Letter
3

**SUBJECT: Draft Environmental Impact Report for General Plan Update
and Green house Gas Reduction Plan**

Exhibit 4.2-5

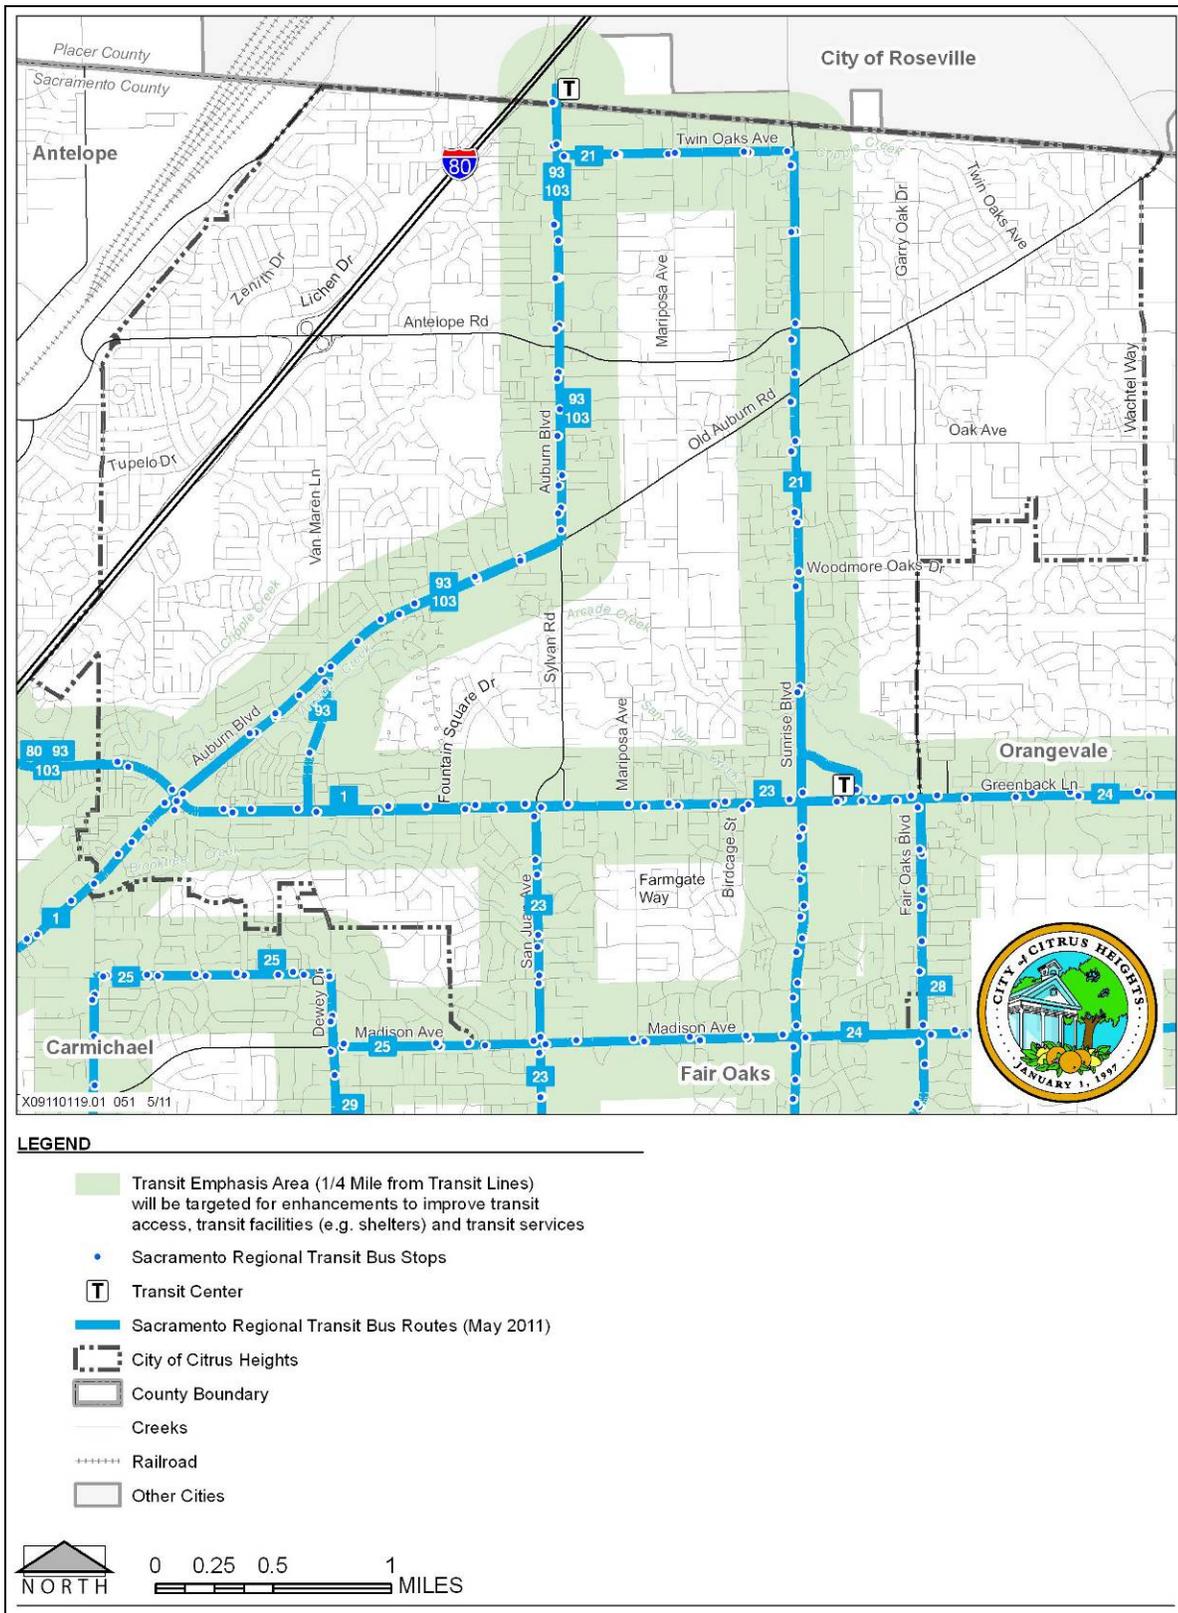
- 1. Correction on page 4.2-18 & 19: The report lists bus Route 29 as serving the City. Route 29 terminates on Dewey Drive south of Madison Avenue half a mile from the City limits. 3-1
- 2. The report does not make any acknowledgment of RT's recently adopted 2035 TransitAction Plan, which provides a 30 year vision for transit in the City. This plan includes the extension of light rail from Watt/I-80 across to Auburn Boulevard continuing east to Sunrise Boulevard and then traveling north towards Roseville. The plan also proposes a European street tram on Greenback Lane connecting to the light rail extension then traveling east to Sunrise Boulevard and continuing south to Rancho Cordova. Attached is the diagram of the TransitAction Plan Network. 3-2

- 3-1 The commenter requests corrections to the DEIR to account for the fact that Route 29 terminates on Dewey Drive south of Madison Avenue, and therefore does not provide service to the planning area. **In response to the comment, the first paragraph under “Transit Routes” on page 4.2-18 of the DEIR is hereby revised as follows:**

In response to the comment, Exhibit 4.2-5 “Existing Transit Facilities” in the DEIR and Map 10 “Transit Emphasis Areas” in the Draft General Plan are hereby revised, as shown on the following pages.
